# FEN DITTON PARISH COUNCIL

## **CWWTPR Stage 3 Consultation - FDPC Response**

## Detailed Response to CWWTPR Consultation 3, February-27 April 2022

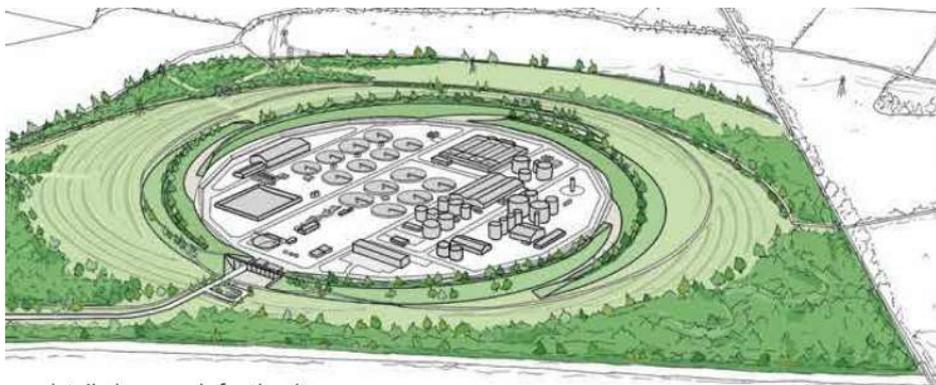
Our questions related to Traffic are:

- Q1) Please provide us with a copy of the highway safety audit noted in the Non-technical Summary 3.4 Vehicular access and the supporting information for its Vehicular Access evaluation;
- Q2) Please confirm existing routes / source destinations for sludge lorries and any additional routes that will be introduced for the proposed plant;
- Q3) Please advise the number of and non-operational office staff and the number of visits / visitors to the current works either annually or monthly.
